# 1 File SUB2006-00285

## **ARMSTRONG SUBDIVISION**

The plat illustrates the proposed 9.42± acre, 2 lot subdivision which is located on the West side of Yeend Street, 800'± South of Baker Street. The subdivision is served by public water and sanitary facilities. The site is located in District 3.

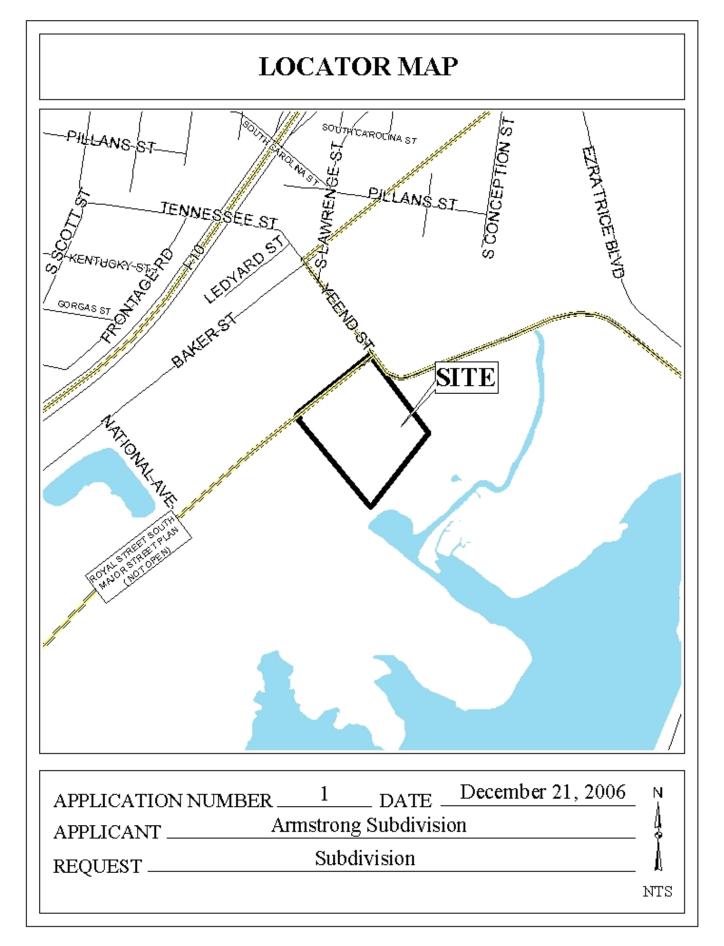
Engineering Comments: Show limit of flood zone/flood way on plat. Show minimum finished floor elevation on each lot. Show any drainage easements. No fill allowed in flood zone without land disturbance permit. The applicant is responsible for verifying if the site contains wetlands. The site can be checked against the National Wetlands Inventory on the COM web site Environmental Viewer. If the site is included on the NWI, it is the applicant's responsibility to confirm or deny the existence of regulatory wetlands. If wetlands are present, no fill allowed without a Corps of Engineers permit. Must comply with all storm water and flood control ordinances. Any work performed in the right of way will require a right of way permit.

While Royal Street Extension is a planned major street, its viability of development to major street standards is questionable. Therefore, in lieu of dedication to provide 50' from centerline, the Commission may consider the placement of additional setback on the plat (75' from centerline) to allow 50' from centerline for the future major street, and the required 25' setback.

The plat meeting the minimum requirements of the Subdivision Regulations and is recommended for Tentative Approval subject to the following conditions: 1) provision of a 75' setback from the centerline of Yeend street to allow for the future major street (50' from centerline for the major street right-of-way and 25' for the required setback); 2) placement of a note on the final plat stating the size, location and design of all curb cuts to be approved by Traffic Engineering and conform to AASHTO standards; and 3) compliance with Engineering Comments (Show limit of flood zone/flood way on plat. Show minimum finished floor elevation on each lot.

Show any drainage easements. No fill allowed in flood zone without land disturbance permit. The applicant is responsible for verifying if the site contains wetlands. The site can be checked against the National Wetlands Inventory on the COM web site Environmental Viewer. If the site is included on the NWI, it is the applicant's responsibility to confirm or deny the existence of regulatory wetlands. If wetlands are present, no fill allowed without a Corps of Engineers permit. Must comply with all storm water and flood control ordinances. Any work performed in the right of way will require a right of way permit).
